COUGAR CREEK DEBRIS FLOOD RETENTION STRUCTURE

Project Update

SUBMITTED TO:
Alberta Environment and Parks
and Natural Resources Conservation Board

February 2019

Footprint Comparison - Overview

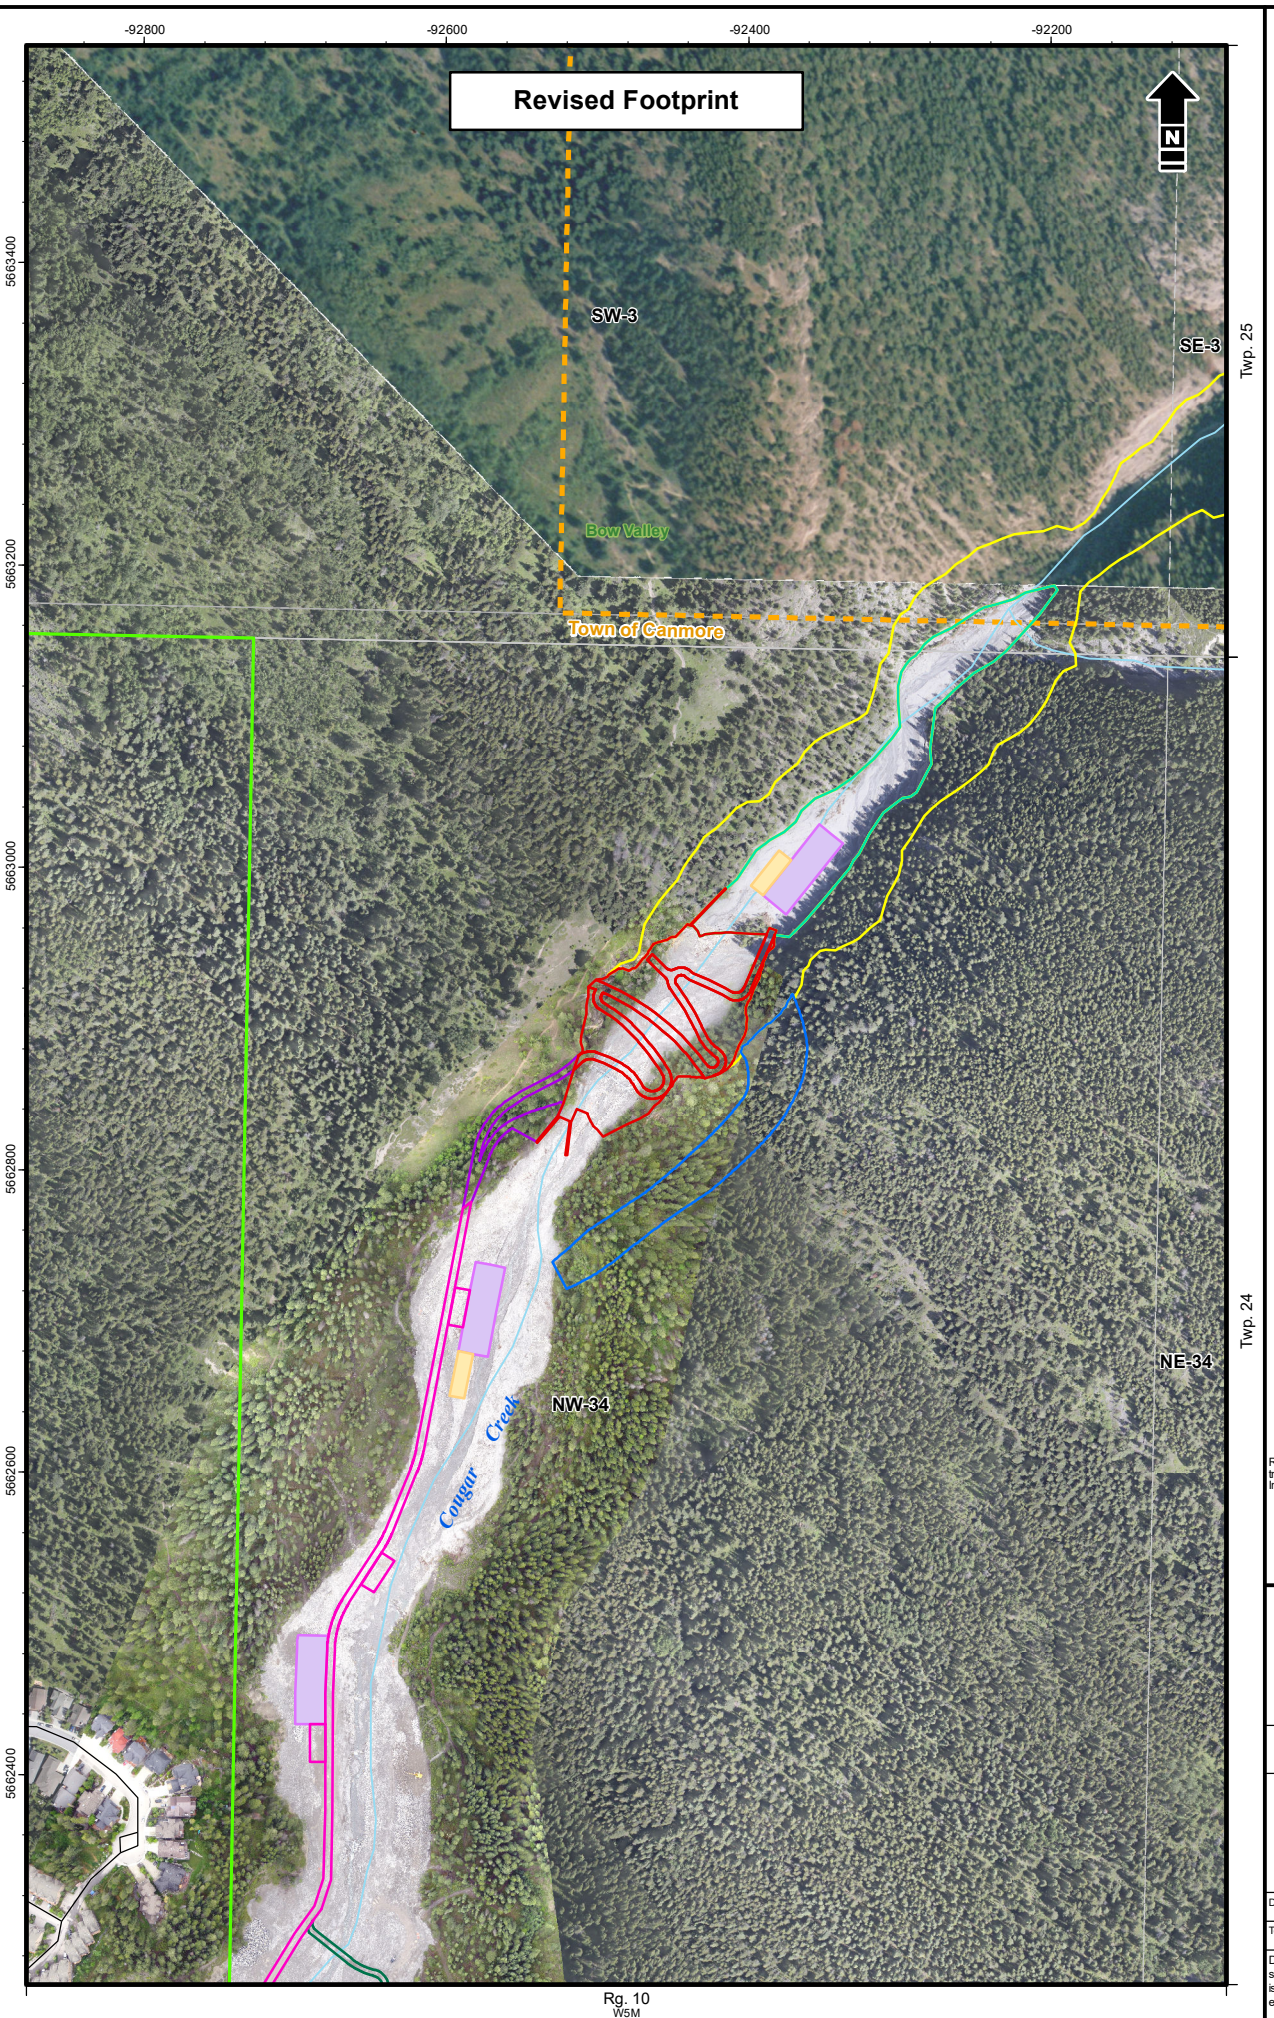
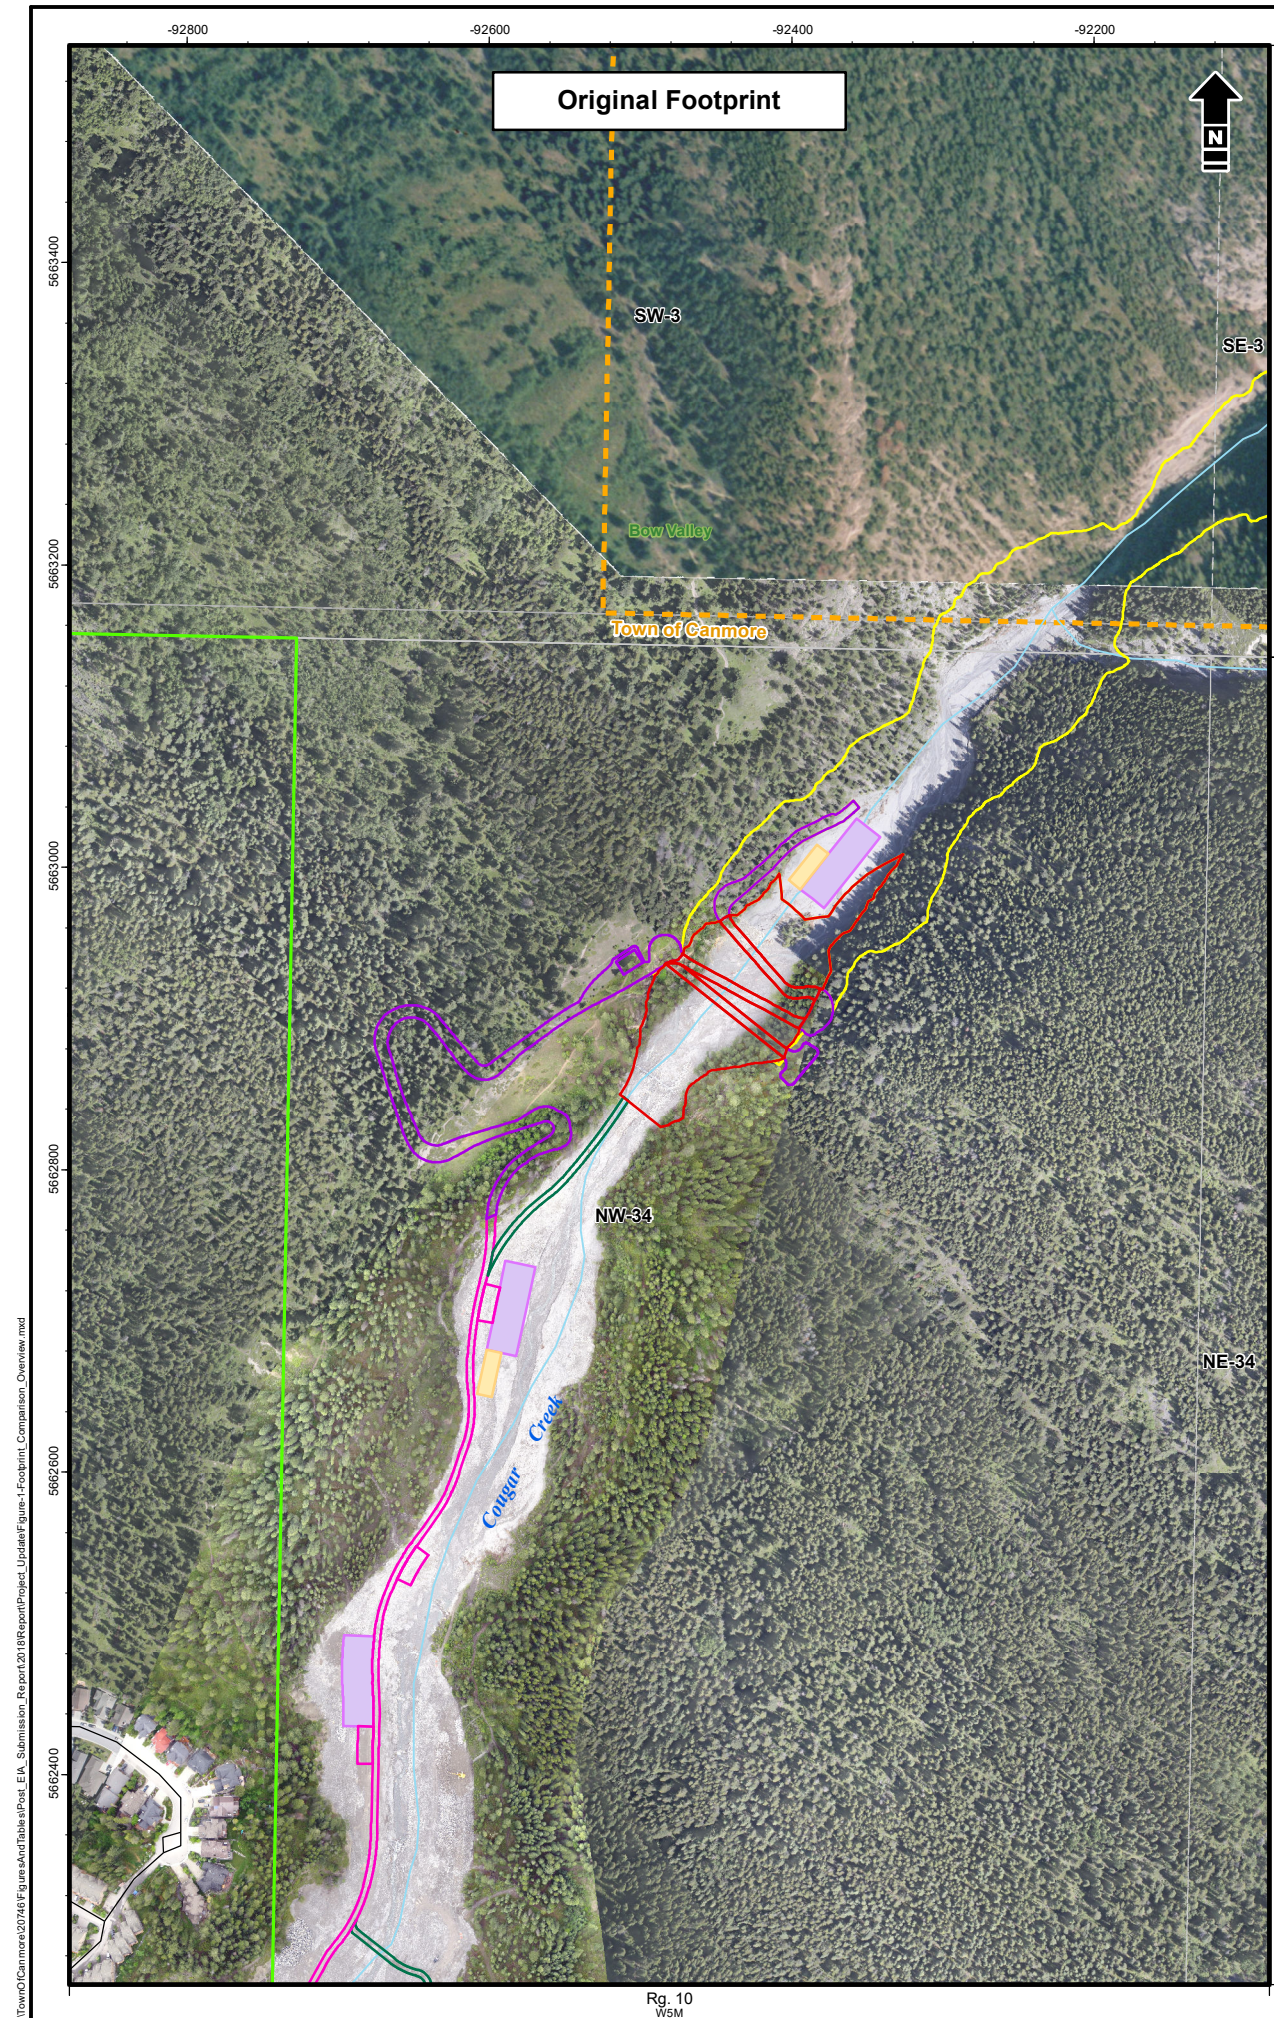
4. **Access Road:** Changing the spillway location allows for the access road to be mostly incorporated into the downstream face of the Structure, rather than on the west abutment as originally proposed (Section 2.4).

As discussed in Section 2.2, removing the spillway from the Structure allows for the majority of the access road to be located on the downstream face of the Structure rather than in the designated wildlife corridor to the west (Figure 1).

Implications for EIA Findings - Locating the access road on the Structure reduces the road footprint within the designated wildlife corridor to the west of the Structure. High quality habitat loss within the corridor is therefore reduced compared to the original design. As recommended in the NRCB decision, the Town of Canmore will continue to support AEP efforts to understand the use of corridors and habitat patches, and to monitor the long-term effects of the Project and revegetation of No-Man's Land on wildlife distribution and movement. Eliminating road construction on the west abutment also reduces interference with established, high-use hiking trails.

Revised Design Rendering

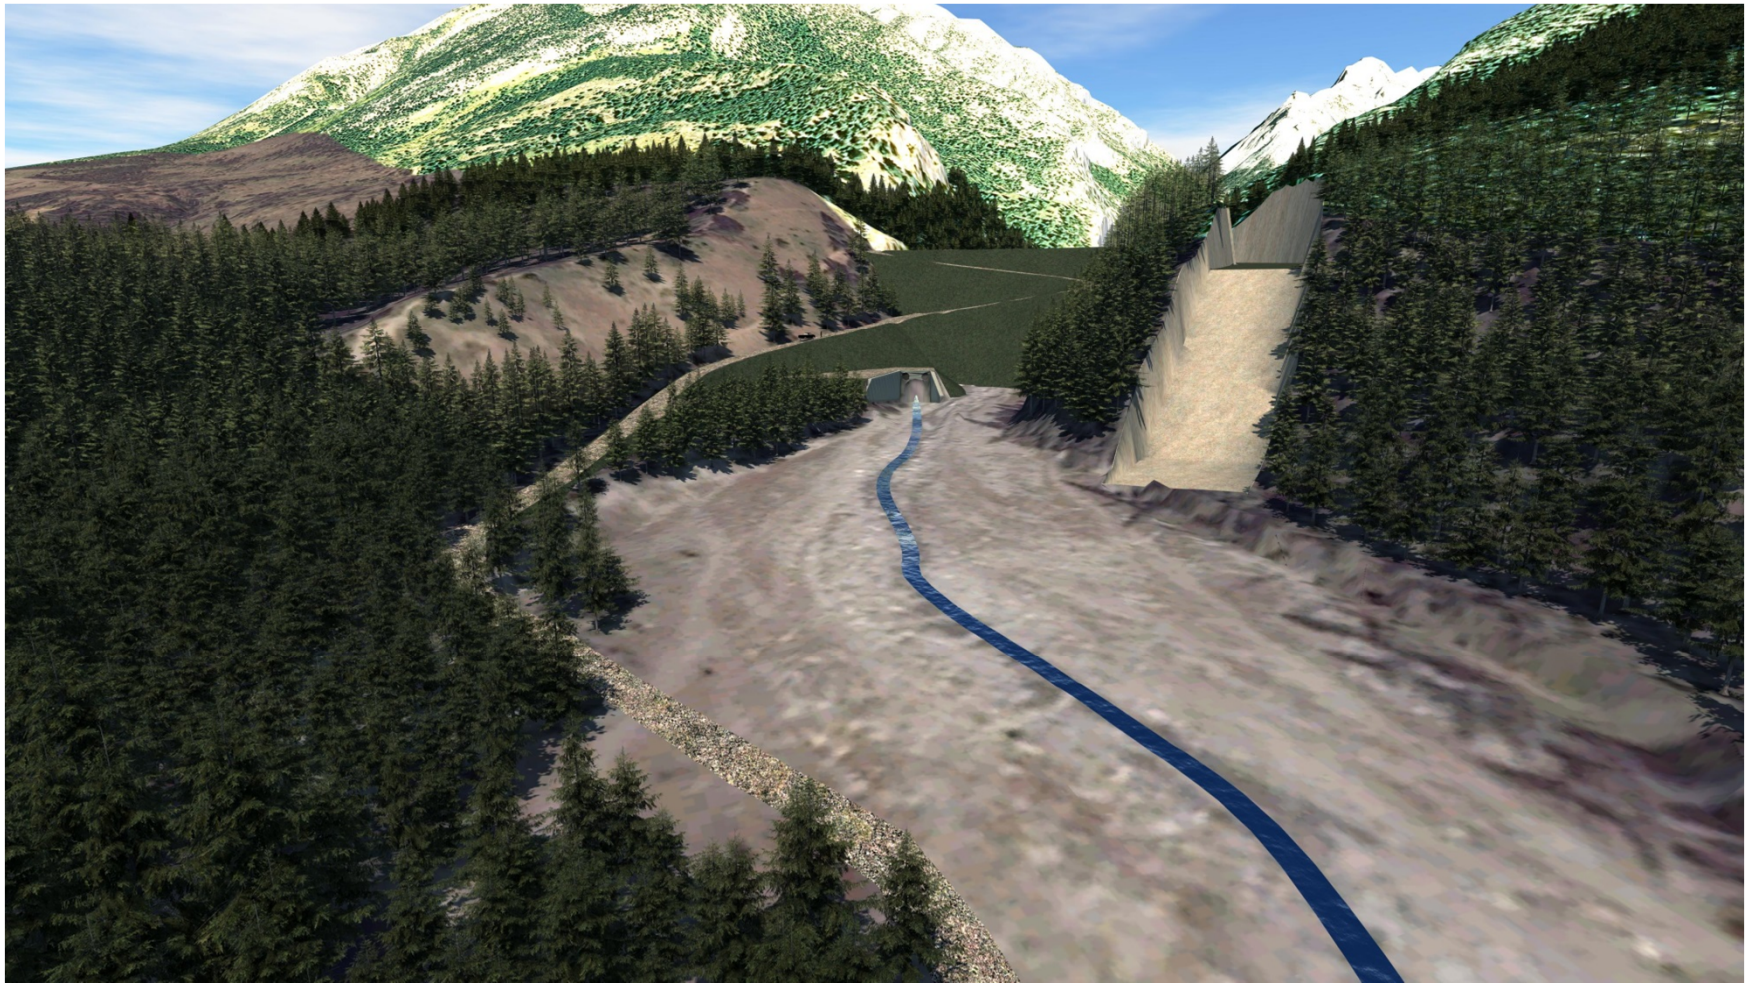
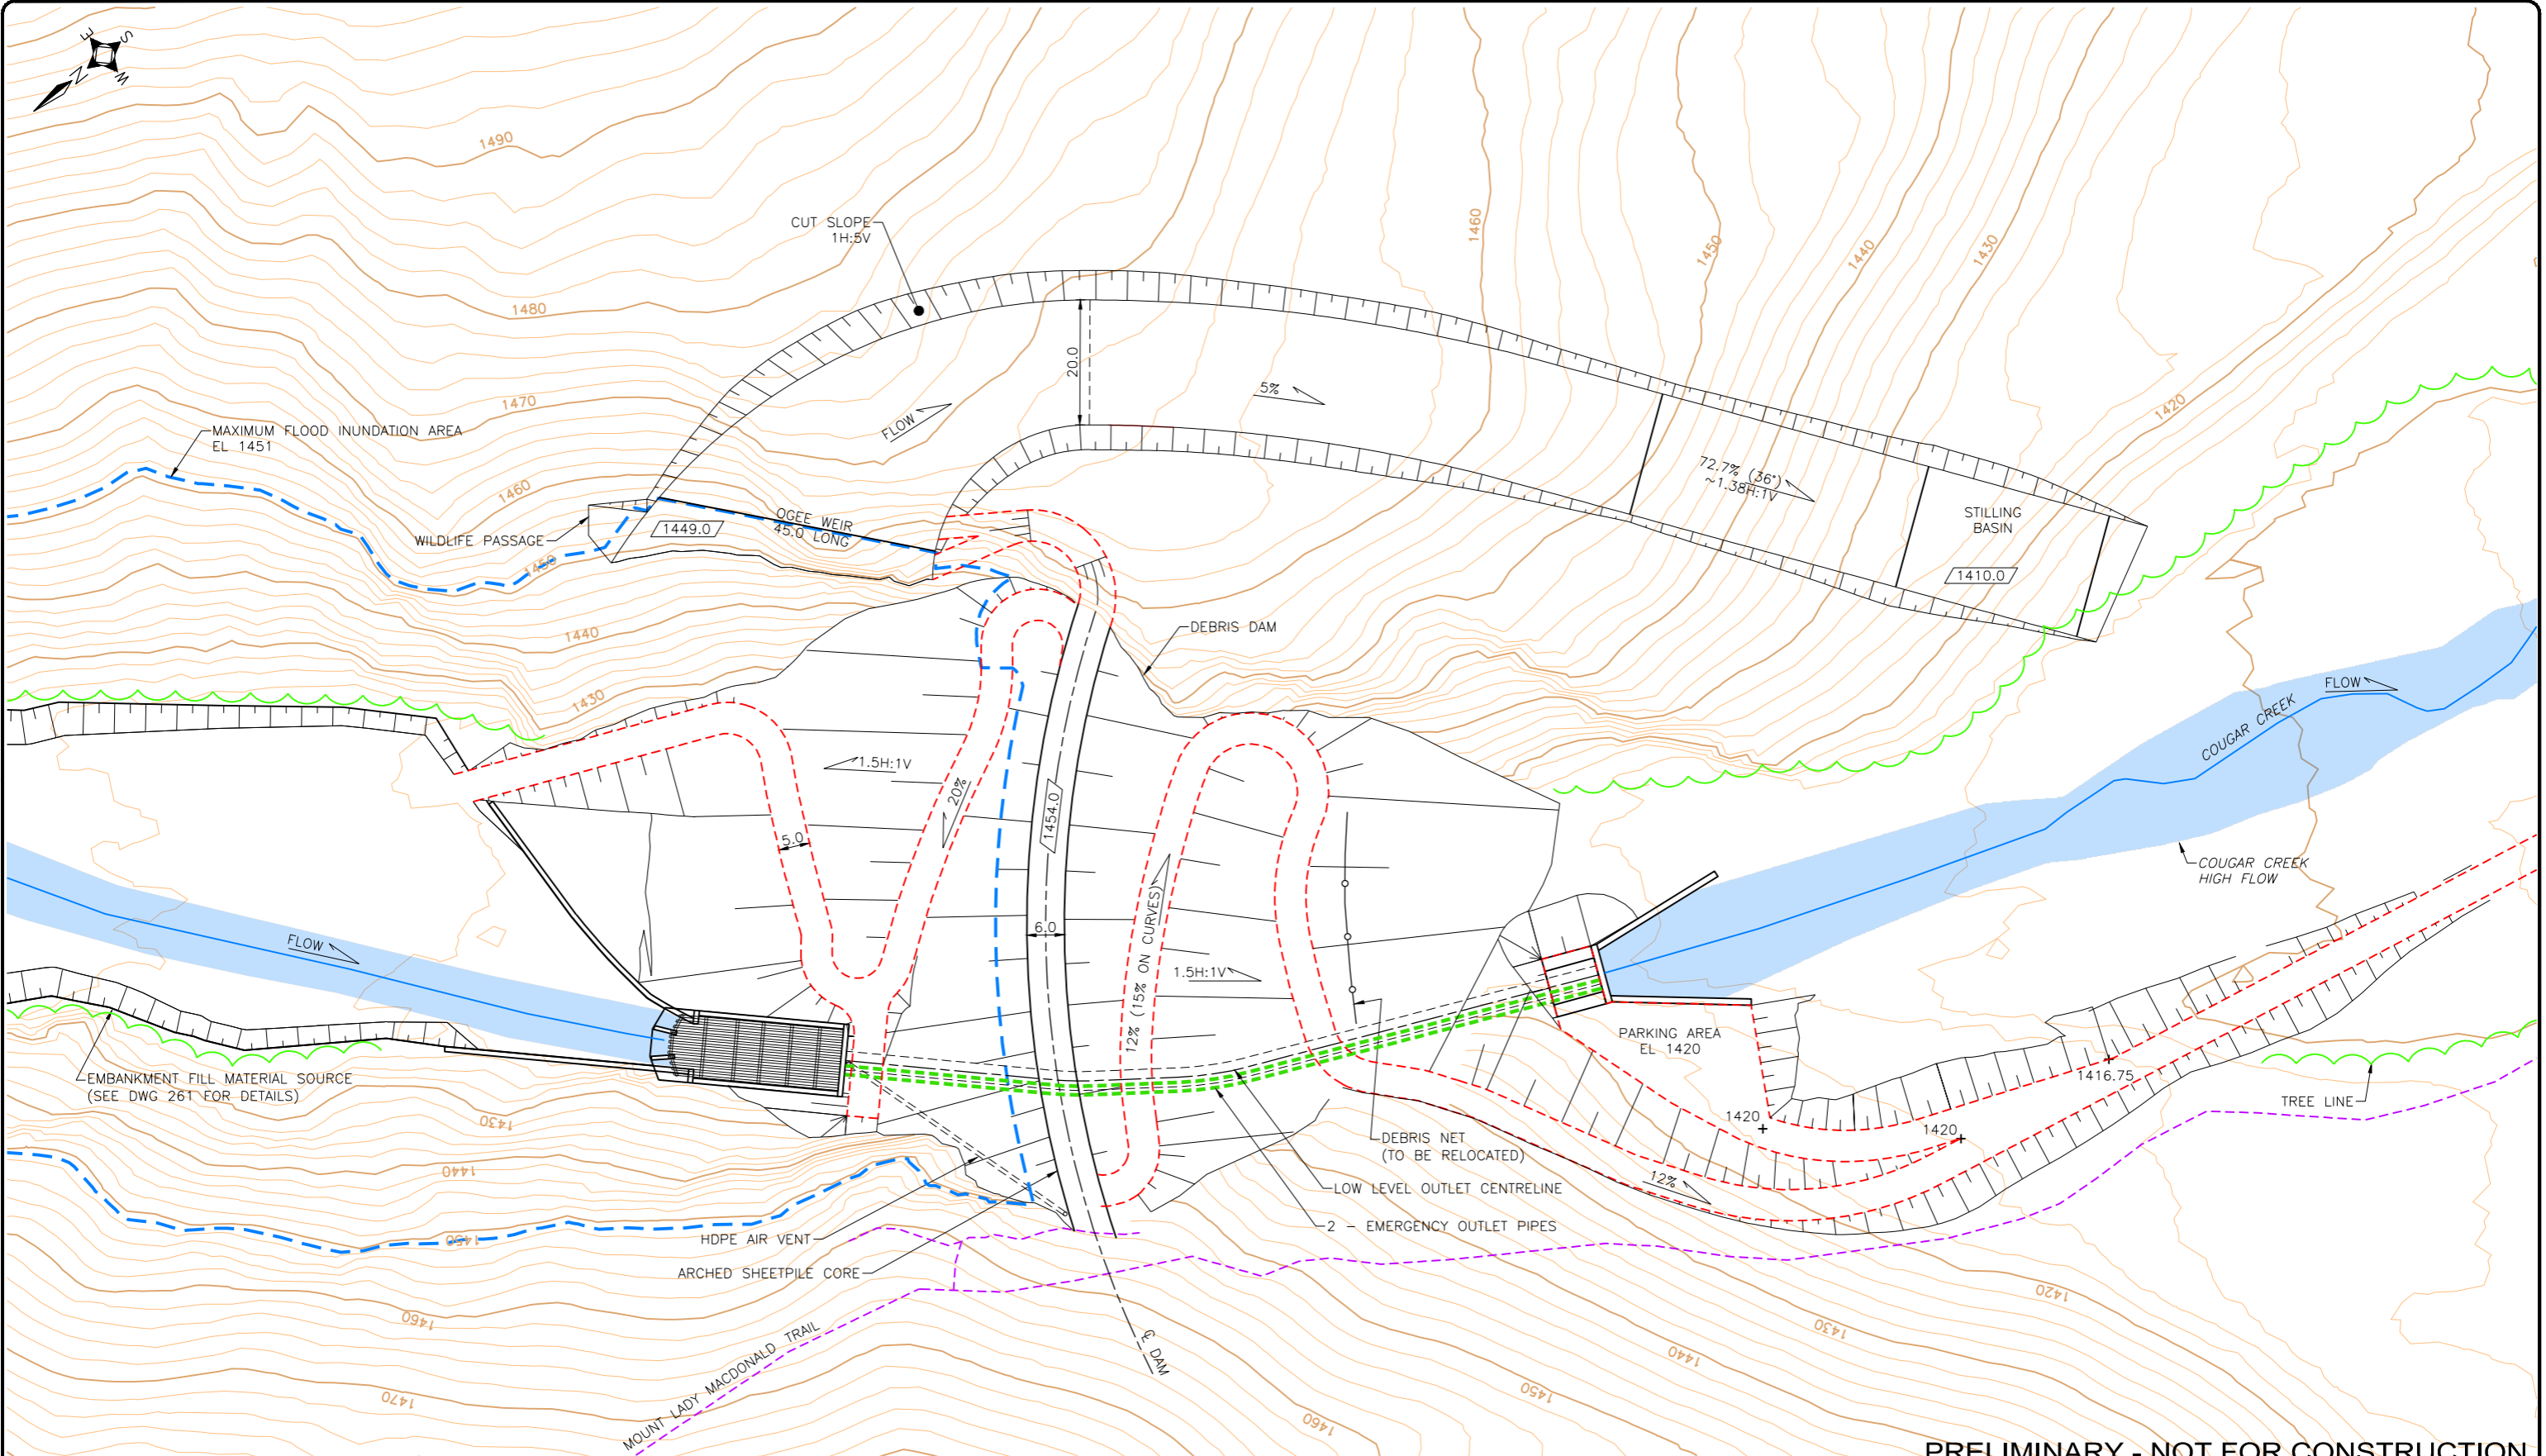
2. **Spillway:** The original design incorporated a concrete spillway on the downstream face of the Structure. The revised design includes a rock-cut spillway located on the east abutment. The rock-cut spillway provides excavated rock for Structure fill and eliminates the need to accommodate flood waters over the crest of the Structure, resulting in reduced design complexity, reduced construction costs and reduced Project related traffic. There is no functional change between these two design options as they both provide the same capacity and the spillway configurations are similar (Section 2.2).

The original design had a Structure crest height of 29.85 m with 34 m sidewalls. Now that the centre of the Structure does not include the spillway, the entire crest of the Structure will be brought to the level of the original sidewall height. The spillway crest elevation remains unchanged and will accommodate the required wave run-up and freeboard for the IDF with the Structure height at 34 m. However, the footprint of the Structure does not materially change since the original design already included 34 m high sides and the slope of the downstream face of the Structure is now slightly steeper. The slope change is possible due to the removal of the spillway from the downstream face of the Structure.

The design changes are described in more detail below, along with key implications for EIA findings associated with each design change. A comparison of the original and revised Project footprint is presented in Figure 1, renderings illustrating the changes are presented in Figures 2 and 3 and a revised plan view is presented in Figure 4.
